Improved Technical Specifications

LaSalle County Station

Volume 8:
Section 3.7

ComEd

FIGURE 4.7-1
SAMPLING PLAN FOR SNUBBER FUNCTIONAL TEST

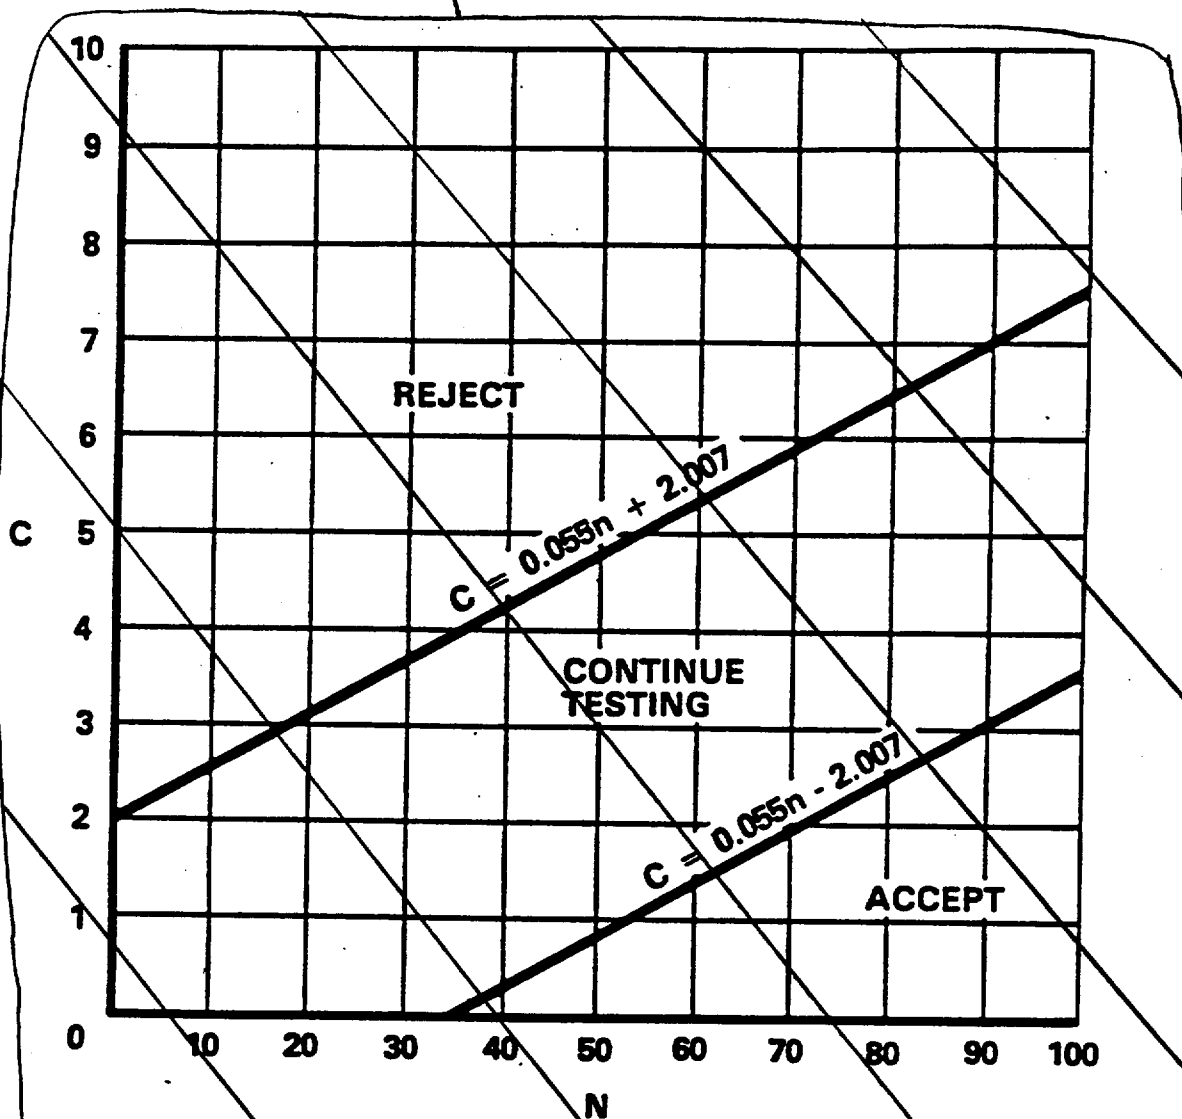
LA1

LA11

FIGURE 4.7-1

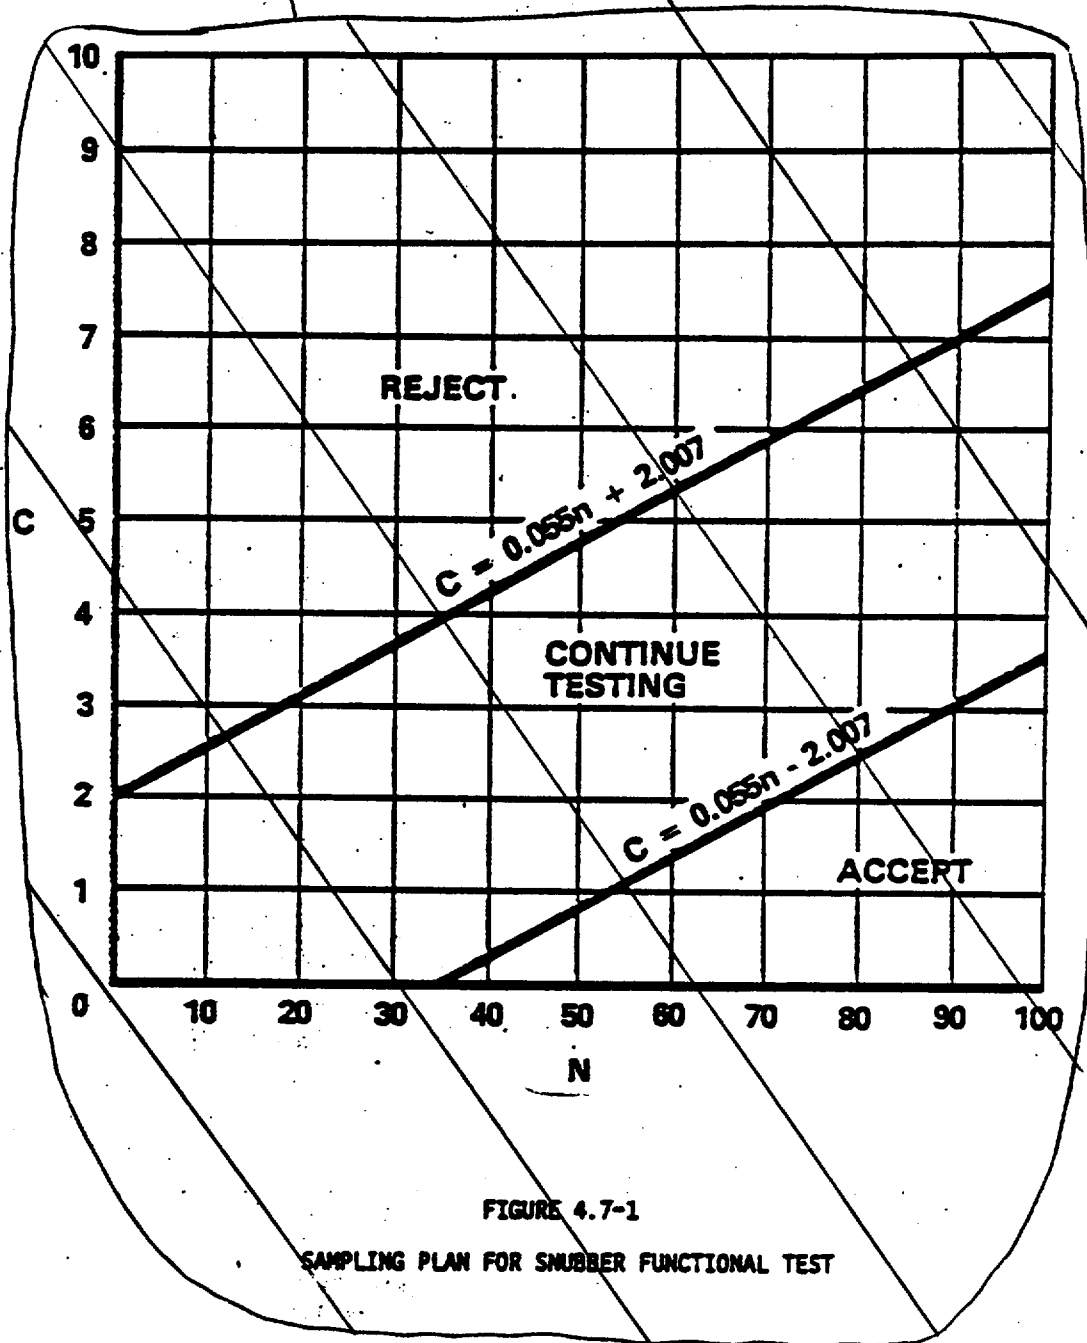
LA.11

JUSTIFICATION FOR DEVIATIONS FROM NUREG-1434, REVISION 1
ISTS: 3.7.2 - HIGH PRESSURE CORE SPRAY (HPCS)
SERVICE WATER SYSTEM (SWS)

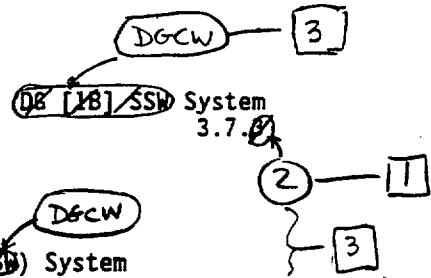
1. This Specification has been deleted since LaSalle 1 and 2 do not have a HPCS SWS.
